MICHIGAN MEMORIAL - PHOENIX PROJECT
PHOENIX MEMORIAL LABORATORY FORD NUCLEAR REACTOR
ANN ARBOR, MICHIGAN 48109-2100

Please correct Approved Route 196-Alt (from Ann Arbor, Michigan to Savannah River Plant, South Carolina) to include the state of Indiana.

University of Michigan, Ann Arbor, MI to Savannah River Plant, SC
Route #196-Alt

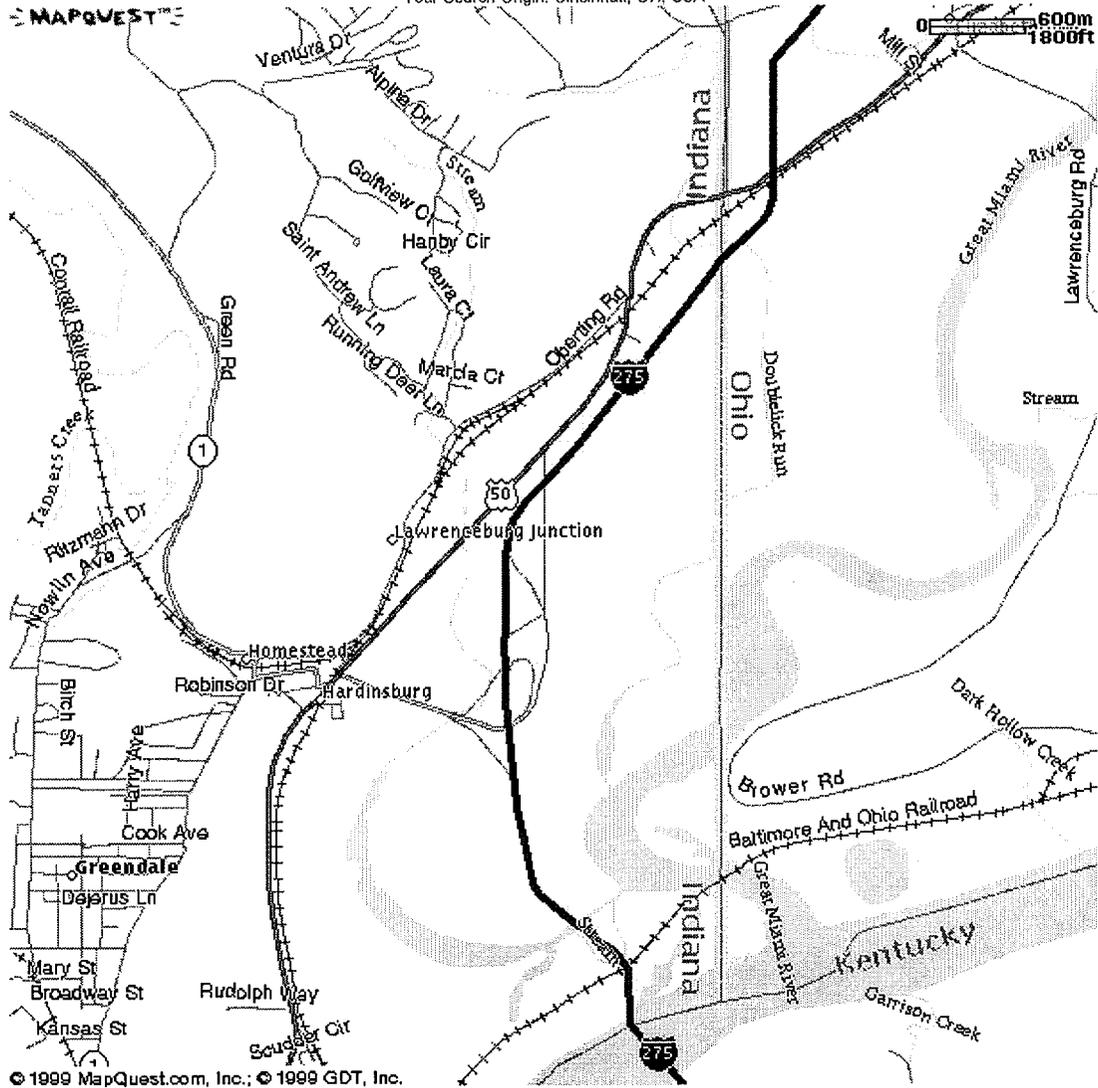
Route 196-Alt was originally proposed and reviewed last year for planned shipments of irradiated research reactor fuel. In the course of those reviews, none of us noticed that I-275 west/south around Cincinnati goes through 4 miles of Indiana countryside before reaching Kentucky. We were advised of this fact by the state of Ohio prior to using the route. We promptly included the state of Indiana in all the advance notifications and escort arrangements. We also called your office at that time to verbally inform you of this inadvertent omission.
